**11 Gibbons Street, Redfern – Social and Affordable Housing (SSD 7749)
Response to Request for Additional Information**

11 Gibbons Street, Redfern (SSD 7449) additional information

Figure 1: Impact to the indicative office layout plan of SGCH shown in yellow

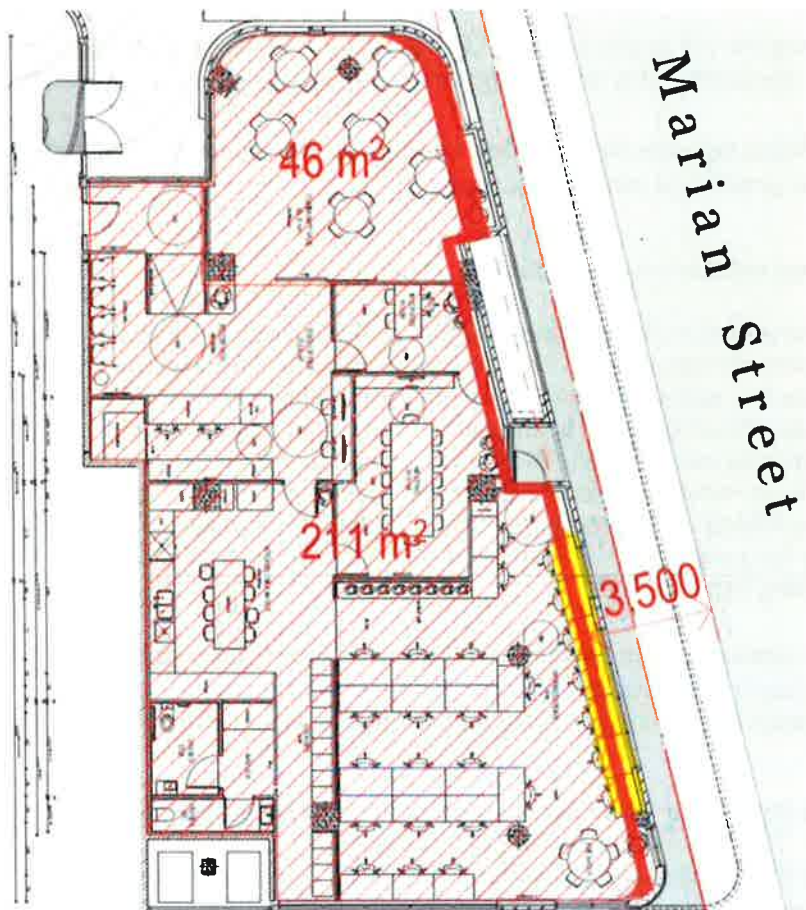
4. *The Commission is also seeking further information about the Project's building setback to Marian Street in consideration of pedestrian amenity*

We note that the IPC would like to understand the capacity of the project to incorporate a further 0.5m setback at ground level to be consistent with the 1.3m setback at 7-9 Gibbons Street referred to in Council's letter dated 12 March 2019.

The capacity of the project to incorporate a further 0.5m setback is limited and not without significant feasibility consequences. The design of this building and its relationship to surrounding streets at a pedestrian level has been the result of significant design workshops in the SRDP process. To achieve the additional 0.5m setback, Levels 1 and 2 of the podium would be required to be cantilevered. There is a concern as to the impact this will have on what is a carefully considered streetscape and this late amendment would appear as an afterthought in the refined design. We argue the amendment will result in no material benefit given the average footpath width has been achieved. Further, we argue the amendment will result in the following implications:

- SGCH require an office to accommodate 26 staff consisting of primarily tenancy and building managers for residents within this building and nearby properties including those in Redfern. The SGCH detailed fitout plan would be severely impacted by the loss of 12m² of GFA along the full length of Marian Street. This would result in the loss of 7 desk spaces along the wall facing Marian Street due to minimum circulation spaces and will result in a maximum of 19 staff being accommodated in the SGCH office. The amendment will necessitate a complete redesign of the office layout and will impact the provision of staff on-site to support the future residents of this development and other residents within Redfern (refer to Figure 1 below).

We submit that the current proposal satisfies the RCUDP setback requirement to Marian Street. We argue that the interpretation to require a 1.3m setback is incorrect, and that the proposal achieves the intention of the control, being the provision of a high level of pedestrian amenity with a 3m wide footpath. An increased setback by 0.5m to Marian Street in our view is unnecessary and will result in no material benefit. It will also significantly impact on the feasibility of the SCGH office space and community hub. The following is provided to support the current siting of the ground floor level:

- The proposed ground floor plan incorporates all mechanical plant / back of house areas and the bicycle storage area typically provided within a basement. SGCH have investigated the option to recover the lost office space by reducing the size of the bike store. However, this cannot be achieved as both the SDRP and Council have requested this space be increased to accommodate additional bicycles and it is needed for the mechanical plant / back of house areas.
